# United States Patent and Trademark Office

APPLICATION NO.	FI	LING DATE	FIRST NAMED INVENTOR	ATTORNEY DOCKET NO.	CONFIRMATION NO.	
10/603,901	03,901 06/25/2003		Cheng-Chieh Chuang	39524.6900	4884	
20322	7590	05/02/2005		EXAM	EXAMINER	
SNELL &		_	BLOUIN,	BLOUIN, MARK S		
ONE ARIZ 400 EAST			ART UNIT	PAPER NUMBER		
PHOENIX,	AZ 8500	40001	2653			
				DATE MAILED: 05/02/2005	DATE MAILED: 05/02/2005

Application No.	Applicant(s)					
	10/603,901	CHUANG ET AL.					
Office Action Summary	Examiner	Art Unit					
·	Mark Blouin	2653					
	The MAILING DATE of this communication appears on the cover sheet with the correspondence address						
Period for Reply							
A SHORTENED STATUTORY PERIOD FOR REPLY THE MAILING DATE OF THIS COMMUNICATION.  - Extensions of time may be available under the provisions of 37 CFR 1.13 after SIX (6) MONTHS from the mailing date of this communication.  - If the period for reply specified above is less than thirty (30) days, a reply - If NO period for reply is specified above, the maximum statutory period - Failure to reply within the set or extended period for reply will, by statute, Any reply received by the Office later than three months after the mailing earn

EXAMINER'S DRAWING

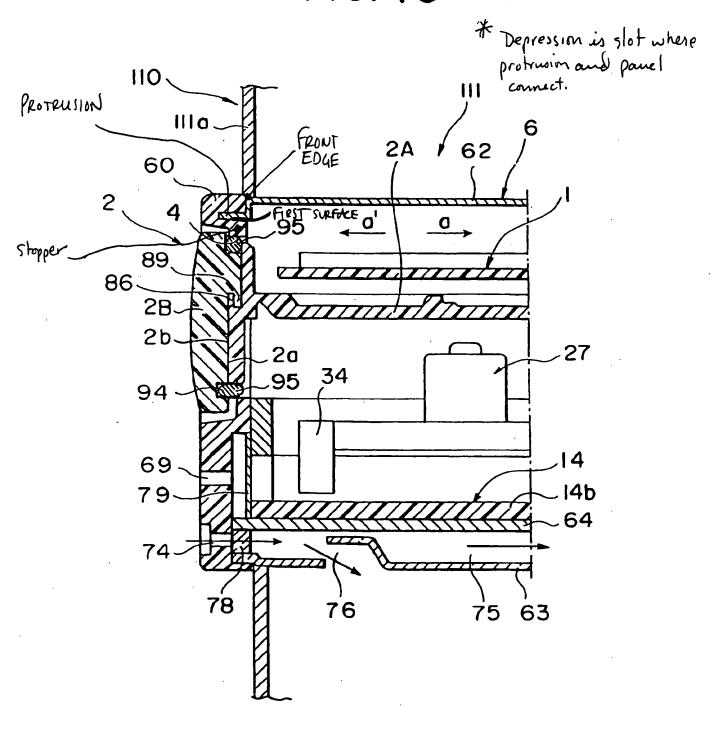
- 2. Claims 1,2,4-7,9-12,14-17, and 19-24 are rejected under 35 U.S.C. 102(e) as being anticipated by Omori et al (USPN 6,650,609).
- Regarding Claims 1,6,11,16, and 21-24, Omori et al shows (Figs. 16 and 32), a disc data reading apparatus comprising a housing (6) having an opening, the opening defining a front edge (See Examiner's Drawing) and the front edge extending to form a protrusion (See Examiner's Drawing), a plurality of stoppers (131a, 131b) being connected to the front edge and extending downward from the front edge, and a panel (60), the panel being selectively connected to the front edge (See Examiner's Drawing), the panel including a first surface (See Examiner's Drawing) corresponding to the protrusion, wherein a force existing between the protrusion and the first surface limits relative displacement between the panel and the front edge for preventing a cracked disc flying out of the disc data reading apparatus.

- 4. Regarding Claims 2,7,12, and 17, Omori et al shows (Figs. 16 and 32), the apparatus, wherein the panel further comprises a depression, the first surface being a side-wall of the depression, as the housing is connected to the panel, the protrusion is received within the depression (See Examiner's Drawing).

The Examiner maintains that Omori et al Figures 16 and 32 are very similar to the Applicants Figure 2c, disclosing similar structures. Omori et al shows a plurality of stopper structures (bottom edge of panel (60) and (131)), which act as a barrier to matter (e.g., pieces of a cracked disc) preventing them from exiting the disk player. The Examiner also notes that the Applicant describes the stopper as a "net structure" in paragraph 0031 of the specification and

the stopper of Omori et al is similarly described as an unwoven cloth (Col 20, line 15), analogous to a net structure. Therefore, the rejection of Claims 1,2,4-7,9-12,14-17, and 19-24 are upheld.
